Town of Hilton Head Island

Design Review Board Meeting

Tuesday, September 10, 2024, 2:30 PM

**1014 William Hilton
Parkway
PLAN SET**

MURAL APPROXIMATE SIZE 37' x 10'

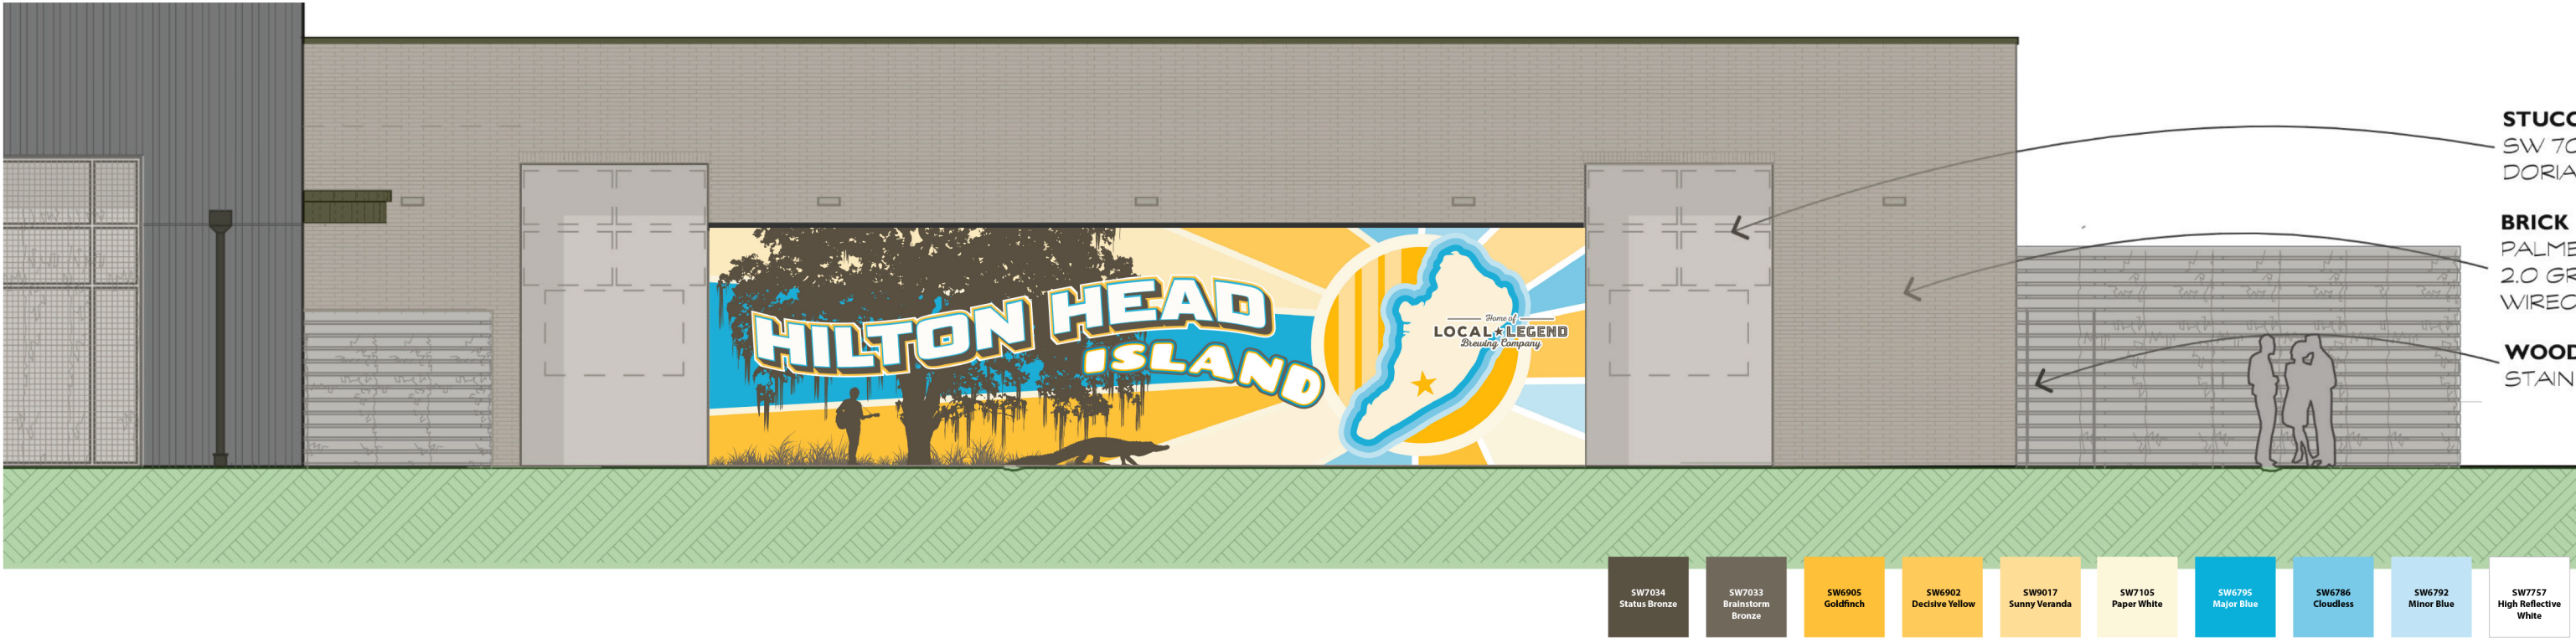
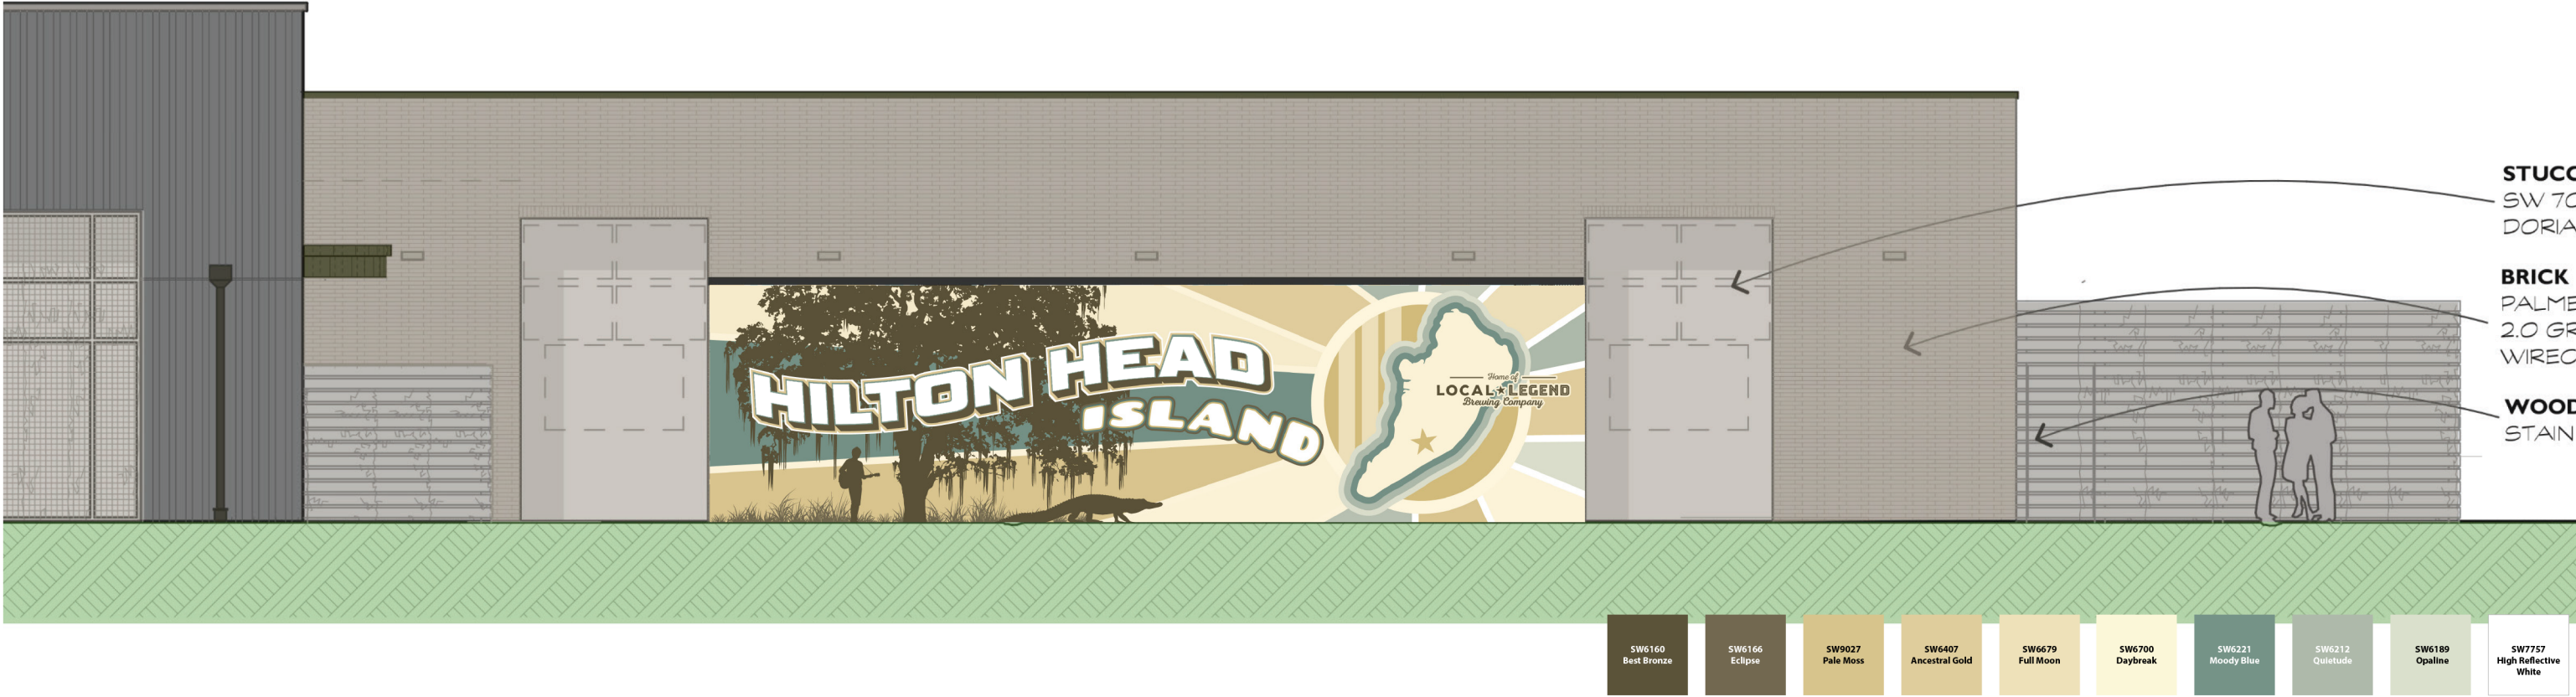
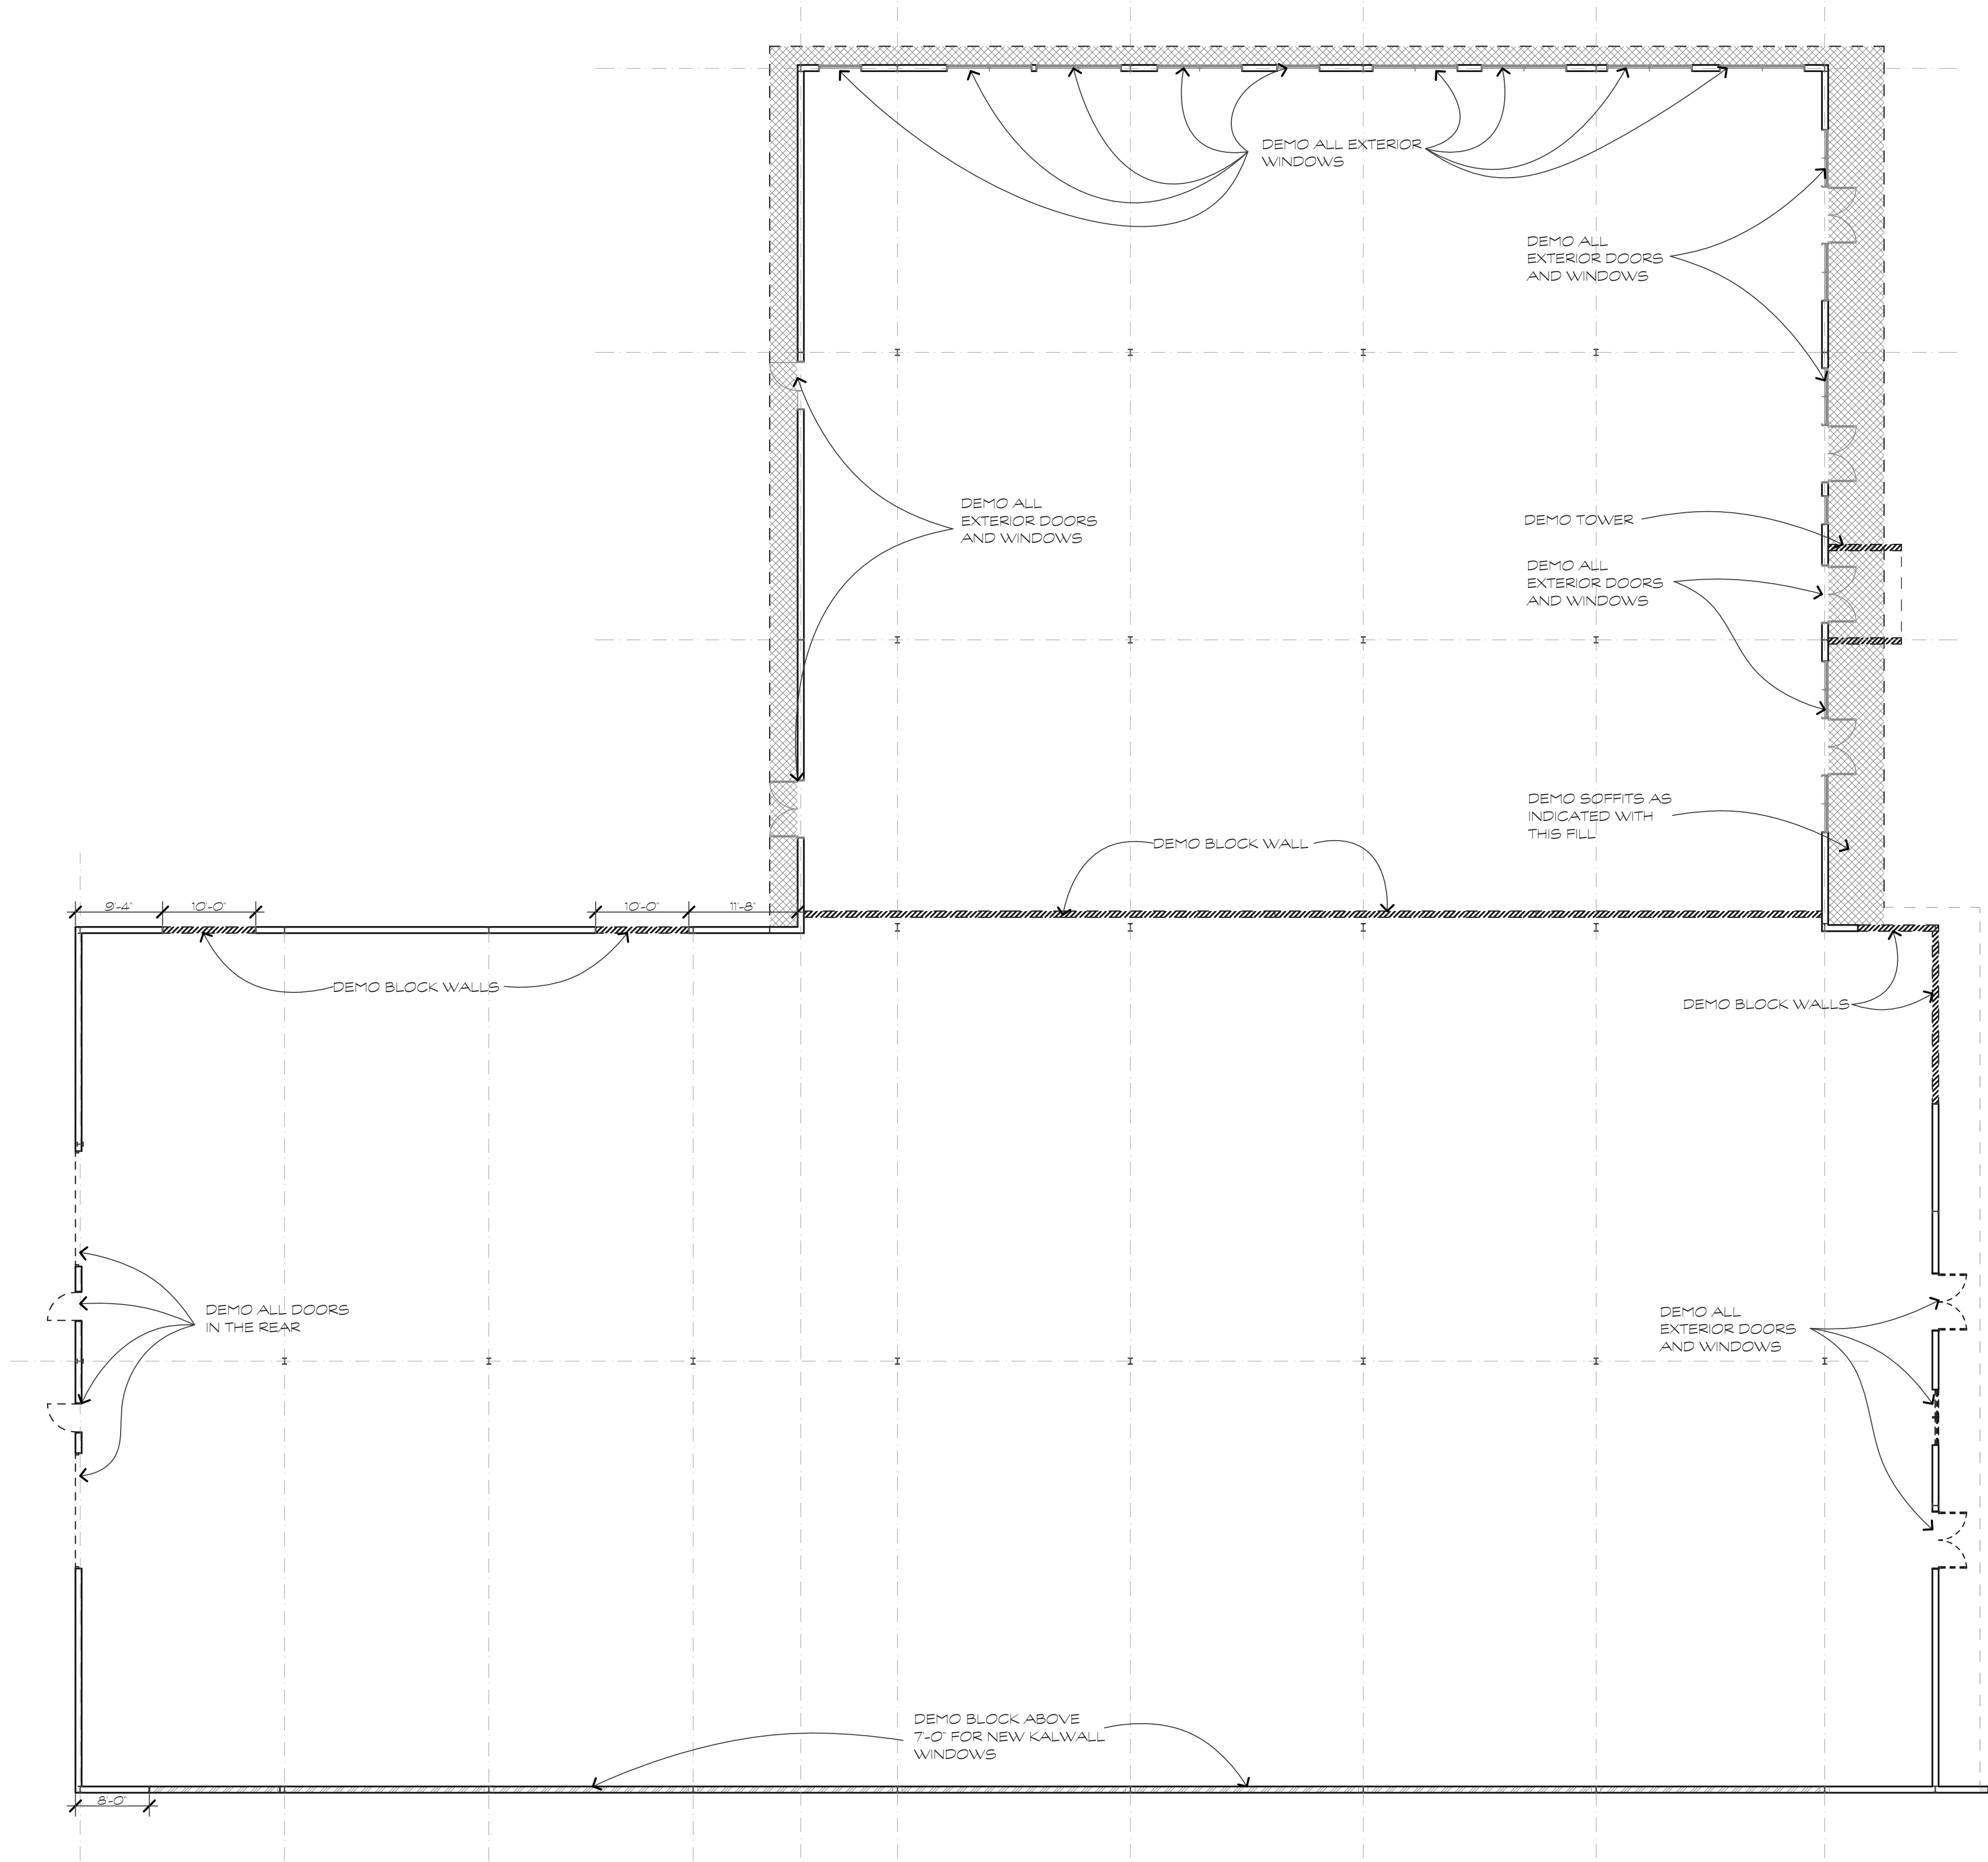
Utilizes natural materials and colors	☒	☐	☐	Option #2 Mural utilizes natural colors.
Avoids distinctive vernacular styles	☒	☐	☐	
Design is appropriate for its use	☒	☐	☐	
All facades shall have equal design characteristics	☐	☐	☒	
Avoids monotonous planes or unrelieved repetition	☒	☐	☐	
Has a strong roof form with enough variety to provide visual interest	☒	☐	☐	
Overhangs are sufficient for the façade height.	☐	☐	☒	
Forms and details are sufficient to reduce the mass of the structure	☒	☐	☐	
Human scale is achieved by the use of proper proportions and architectural elements	☒	☐	☐	
Utilizes a variety of materials, textures and colors	☒	☐	☐	A 11x 17 materials board is required for final review.
Incorporates wood or wood simulating materials	☒	☐	☐	
Windows are in proportion to the facade	☐	☐	☒	
Details are clean, simple and appropriate while avoiding excessive ornamentation	☐	☐	☒	
Utilities and equipment are concealed from view	☐	☐	☒

1. Staff recommends approval of the alteration submittal with the following conditions to be provided prior to the Final submittal:
 - a. Physical Material and Color Board on a 11”x17” - ask for example if needed
 - b. Colors shall be of a natural base to blend into the architecture and landscaping.
 - c. Provide any lighting specs that will be used to enhance the mural.
